ADDENDUM #1

Sylvan Union School District

Site Work for New Portables Group 2 – (4) Sites

BID NUMBER: 2023-24 #5

SYLVAN UNION SCHOOL DISTRICT
ORCHARD ELEMENTARY SCHOOL
(1) NEW PORTABLE CLASSROOM
PARTIAL GRADING/UTILITY PLAN

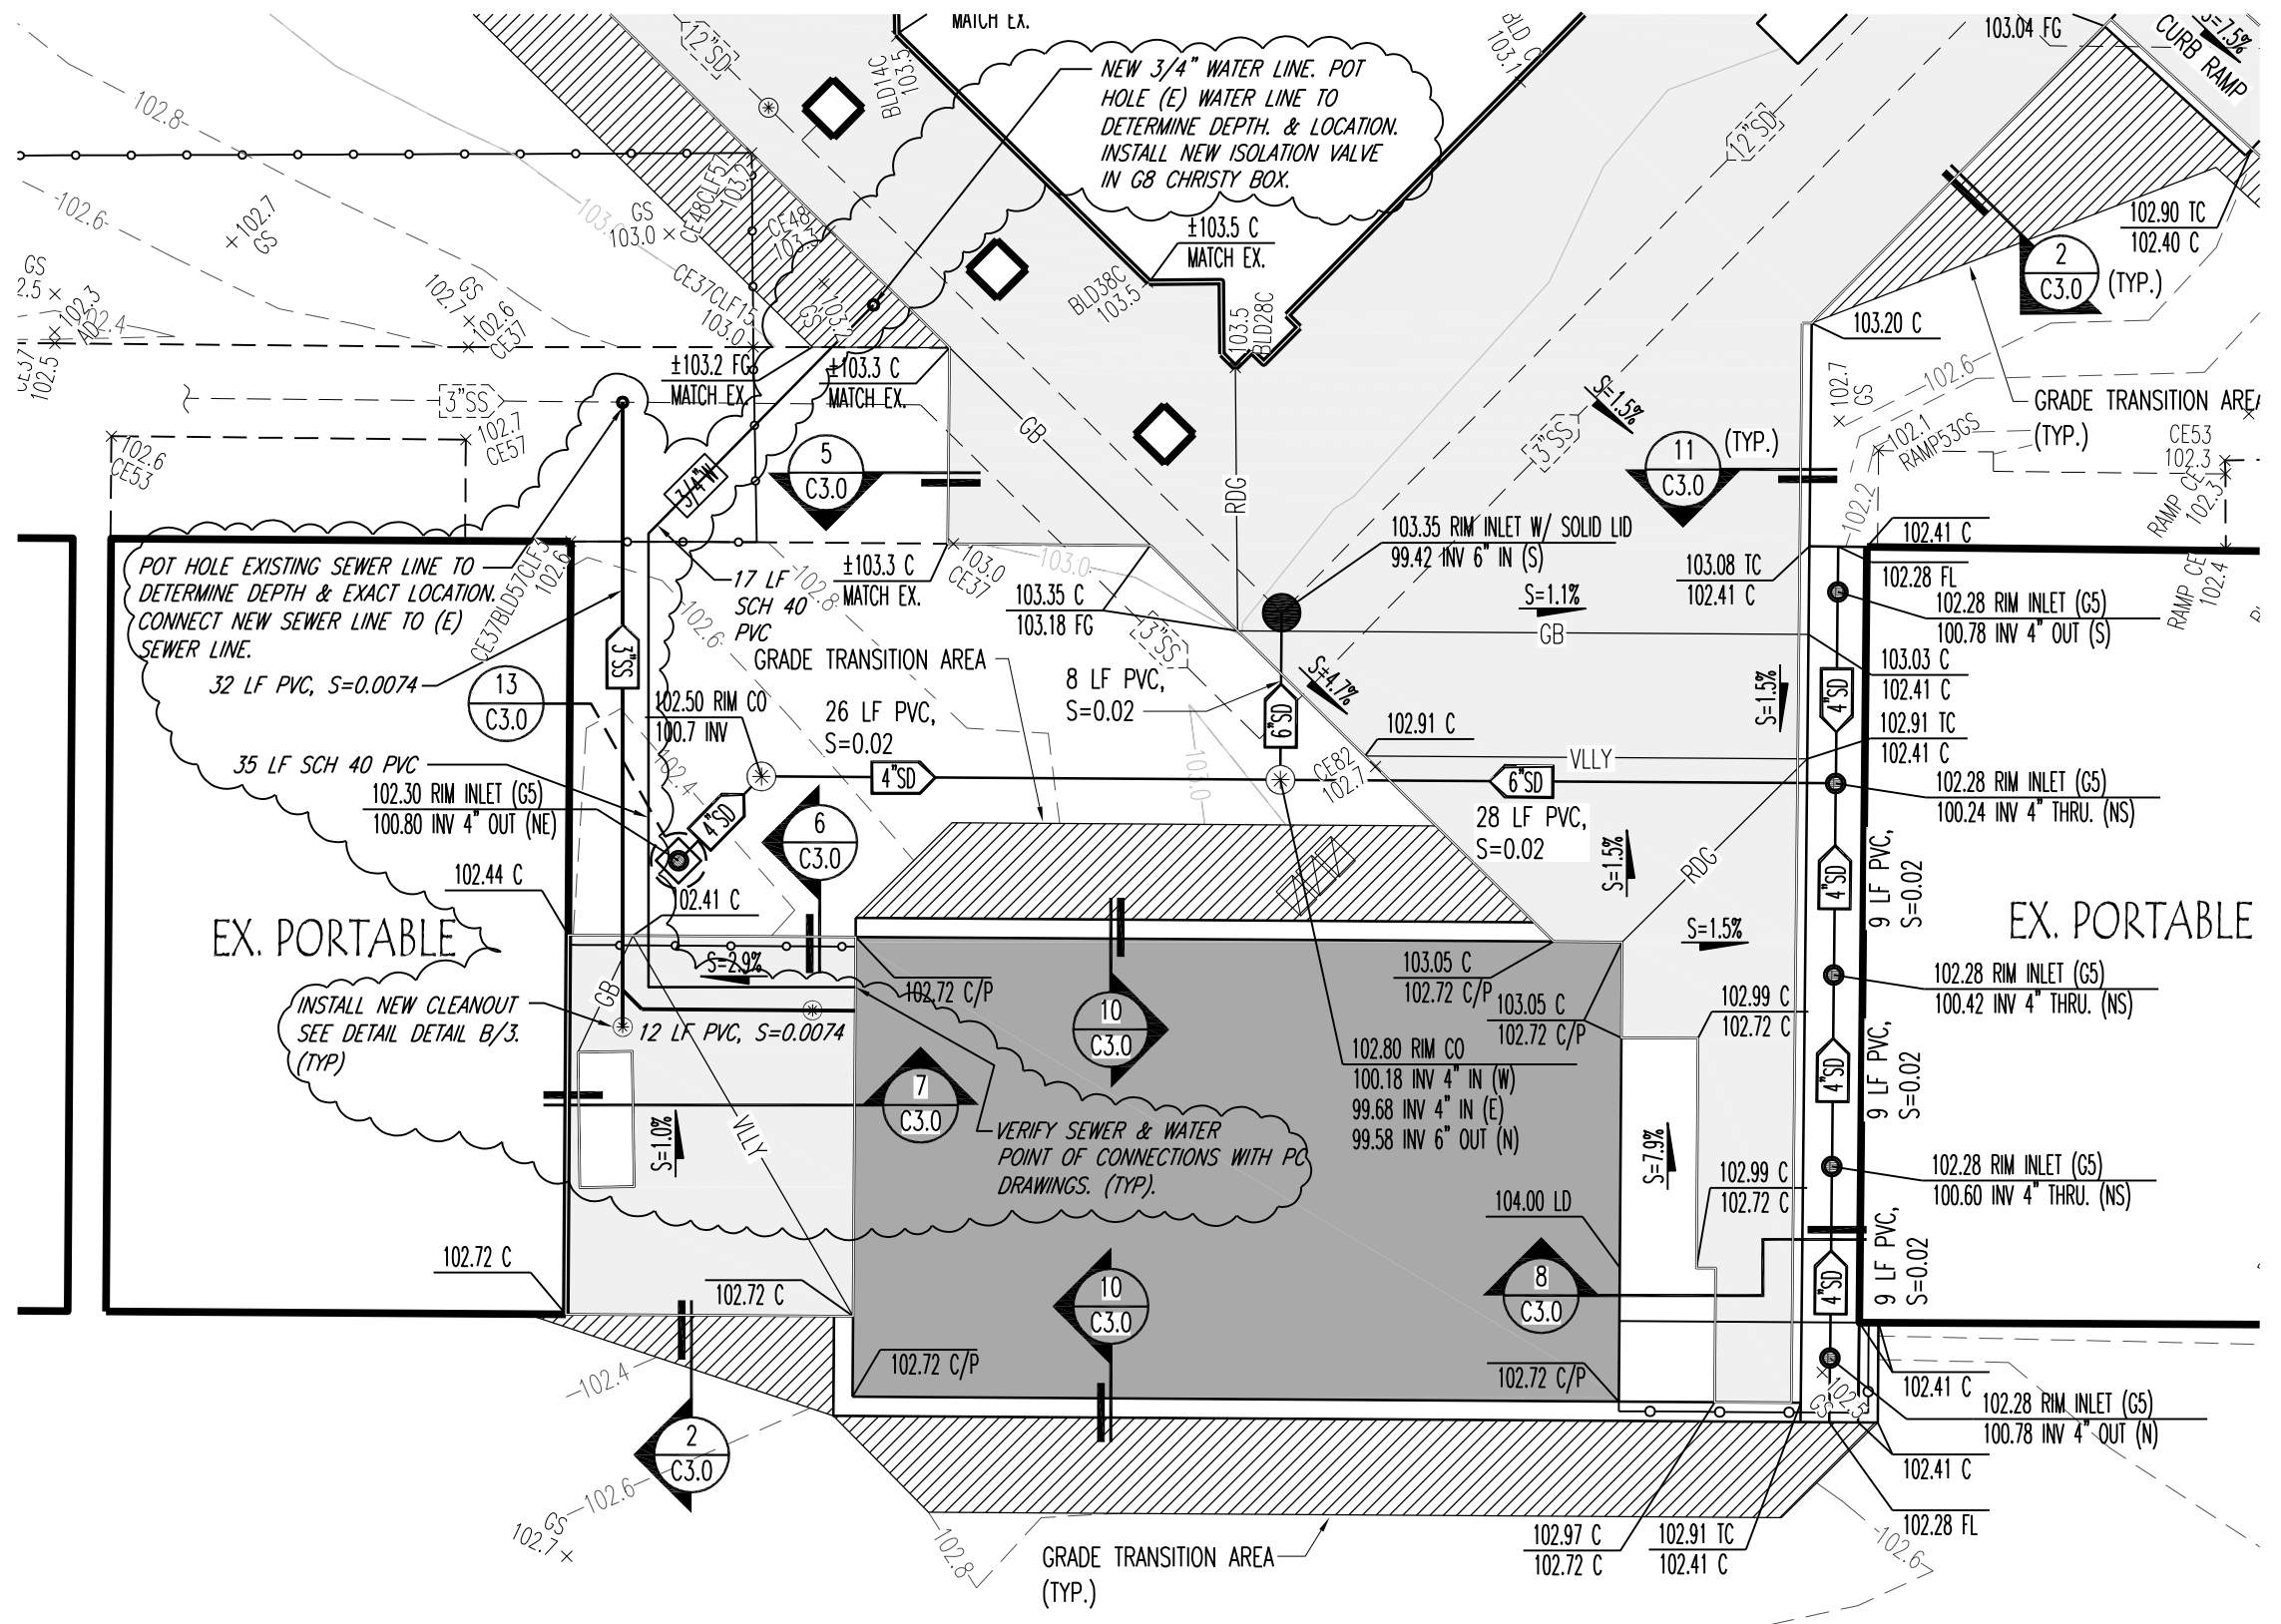
ITEM #1.1: ***Orchard Elementary School & Stockard Coffee Elementary – Water & Sewer Service:*** Provide new water and sewer service to new portables. See attached exhibit.
